# **Fiat Scudo - Poor air conditioning system performance | HELLA**

**Scudo 1.6D Multijet 90**

**Year of manufacture: from 2007 until VIN 84160387**

Poor air conditioning system performance

- Old model types -

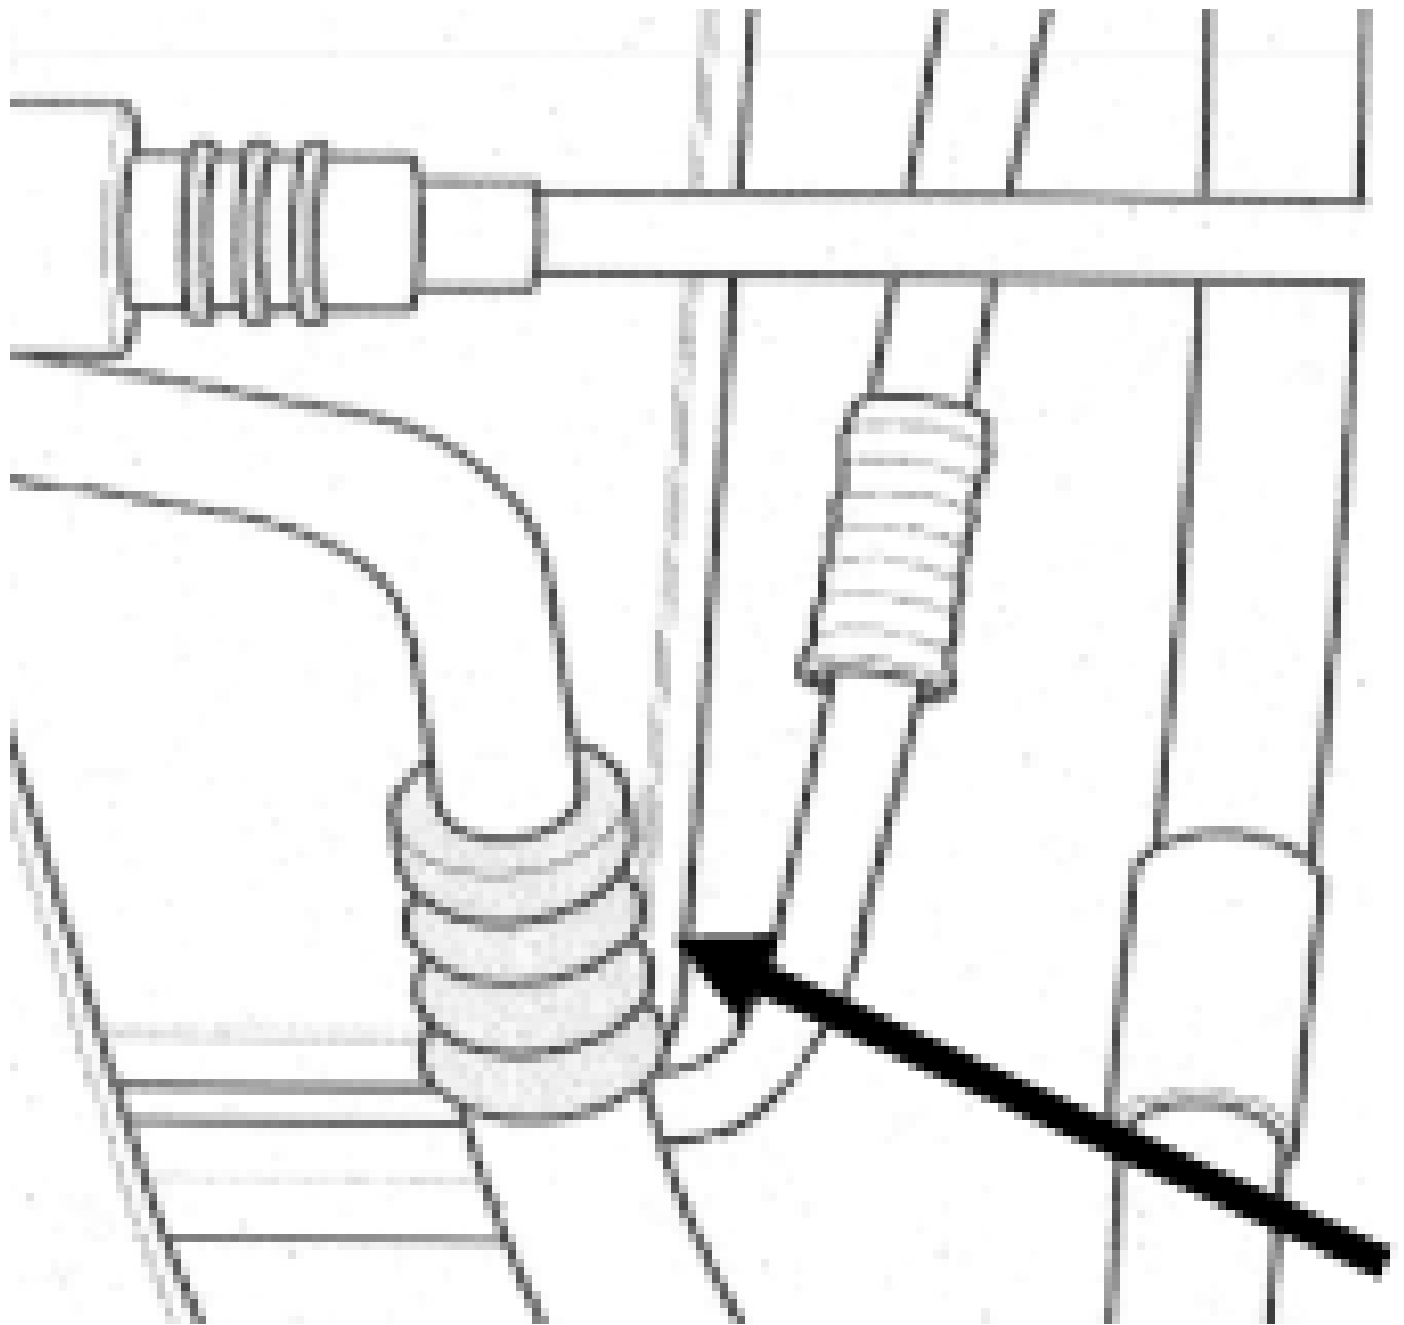
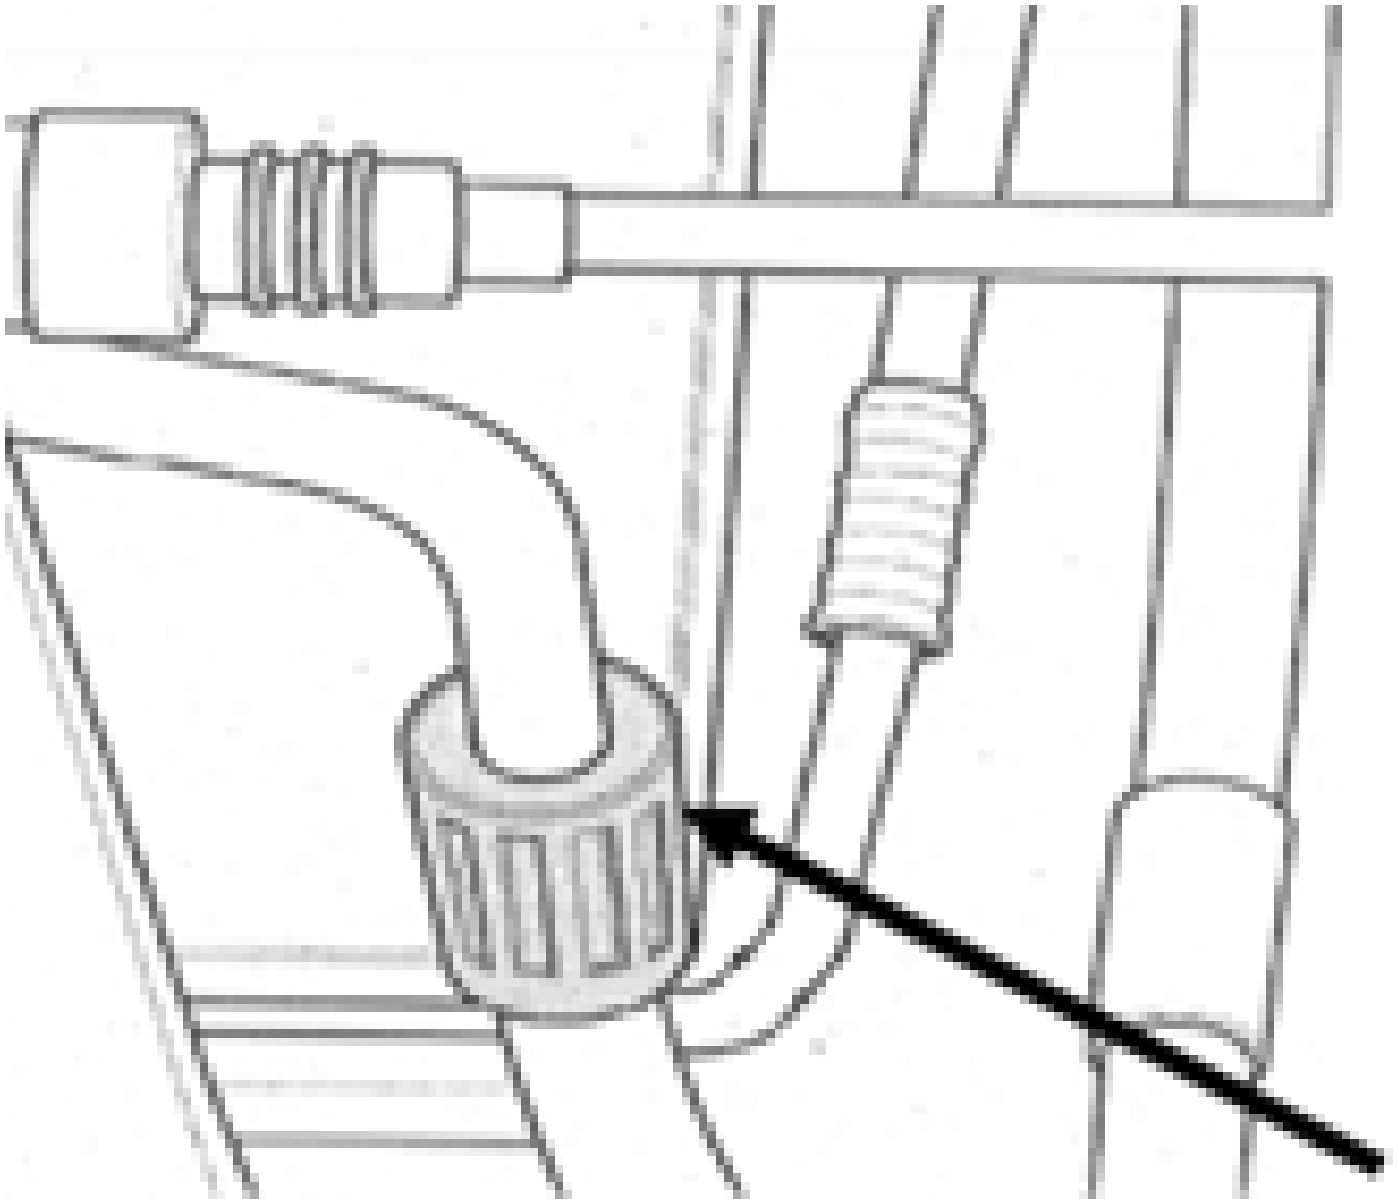
If the vehicles mentioned above experience poor air conditioning performance or a loss of coolant, the possibility of a coolant leakage between the condenser and compressor must be considered.

Check the coolant line for the correct model type and replace if necessary. (see figures)

This is the modified model type from the vehicle manufacturer: [Spare parts]

- 1 unit: Coolant line: (Spare parts): 140142280

- 2 units: O-ring: (Spare parts): 9645950980
